Estonian Transport Administration
Maanteeamet
(70001490)
info@transpordiamet.ee
info@mnt.ee

No. NK- 0451/2025

*Regarding Identified Material Deviations from Technical, Safety and
EN Standard Requirements in an EU Co-Funded Project*

Pursuant to the procurement procedure launched on 31 December 2020 by the Estonian Transport Administration (hereinafter – the Contracting Authority) titled “*Construction of the Kanama–Valingu 2+2 road section of km 29.6–34.2 of the Tallinn ring road No. 11*”, Reference No. 231161 (hereinafter – the Procurement), a construction contract was concluded with the successful tenderer AS TREV-2 Grupp (registry code 10047362) for the performance of works at the project site.

Figure 1

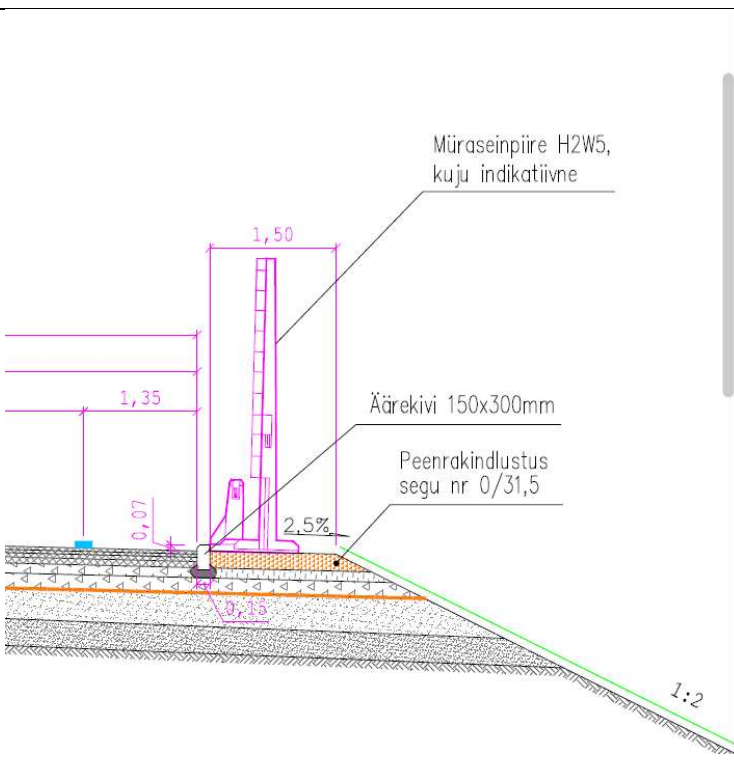
The Procurement documentation (bill of quantities and design drawings) indicates the following items (see Figure 1):

Although the safety barrier systems installed at the Site are declared as compliant with EN 1317, the actual construction solution does not comply with the fundamental principles of the standard, which govern the safe operational performance of such systems. Under EN 1317 testing methodology:

Figure 2

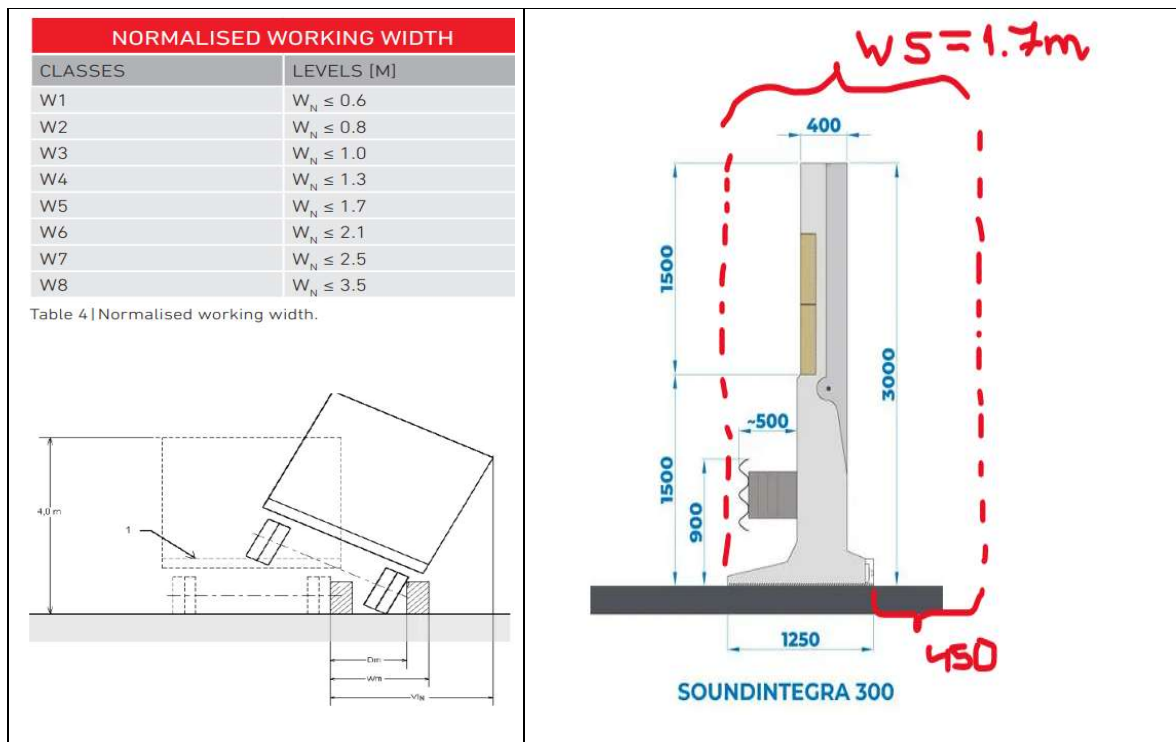
At the site, SoundIntegra 300 (Kee srl) barrier systems have been installed with the following declared parameters:

- working width W5 = 1.7 m (EN 1317 test result);
- physical width of the barrier: 1.25 m.

Accordingly, safe and certification-consistent operation requires a minimum clear verge of 0.45 m behind the barrier, as also follows from publicly available manufacturer information [SoundIntegra - Kee srl](#) (Figure 2)
